Access Compliance Report

Public Rights-of-Way

(Curb Ramps)

Intersection ID: 48459	Main Street: TARPWAY_RD	Cross Street: QUINN_DR	Location: W
ADA ID: 072706FCBC5F	Ramp Type: Perp	Initial Pass/Fail: Fail	Overall Compliance: No
		Severity Score: 10

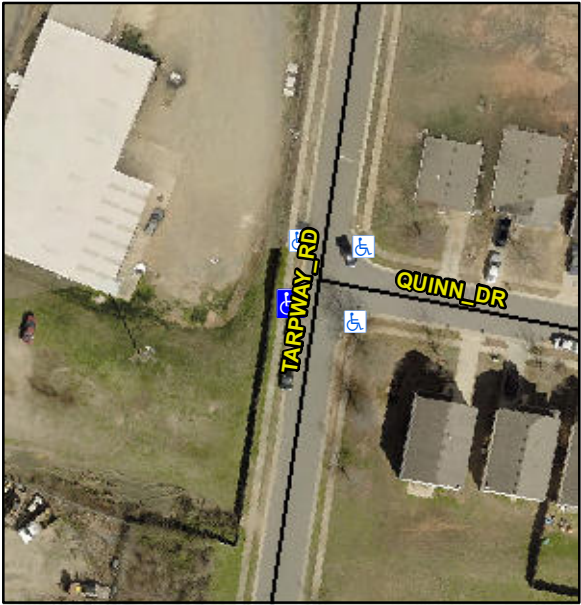
Codes/Mitigation Info/Possible Solution			Field Measurements/Component Compliance		
	Possible Solutions:		Compliance	Description	Data
	Remove & Replace Entire Ramp.		N/A	Ramp Length (in)	48.0
			No	Ramp Width (in)	47.0
			N/A	Flare Type LT	N/A
			N/A	Flare Slope LT (%)	N/A
			N/A	Flare Traversable LT?	N/A
			N/A	Landing Length (in)	N/A
			N/A	Landing Width (in)	N/A
			N/A	Landing Slope (%)	N/A
			N/A	Landing X Slope (%)	N/A
<p>Surveyor Notes:</p> <p>N/A</p> <p>PROW/ADA:</p> <p>Not Found, R304.5.1</p>			N/A	Flare Type RT	N/A
			N/A	Flare Slope RT (%)	N/A
			N/A	Flare Traversable RT?	N/A
			N/A	DWS Provided?	N/A
			N/A	DWS Contrast?	N/A
			N/A	DWS Length (in)	N/A
			N/A	DWS Full Width?	N/A
			N/A	DWS Offset (in)	N/A
			N/A	Gutter Ponding?	N/A
			N/A	Gutter Lip Ht (in)	N/A
			N/A	Painted X Walk1?	No
				X Walk 1 Direction	To SE
			N/A	X Walk 1 Width (in)	N/A
				X Walk 1 Slope (%)	3.7
				X Walk 1 X Slope (%)	3.1
			N/A	Ramp inside XWalk1?	N/A

Road Slope (%)	N/A
				Road X Slope (%)	N/A
			N/A	Any Obstructions?	N/A
				Obstruction Type	
Total Cost:			\$	1850.00	
			N/A		N/A
			Yes	Surface Condition? (G/P)	Good
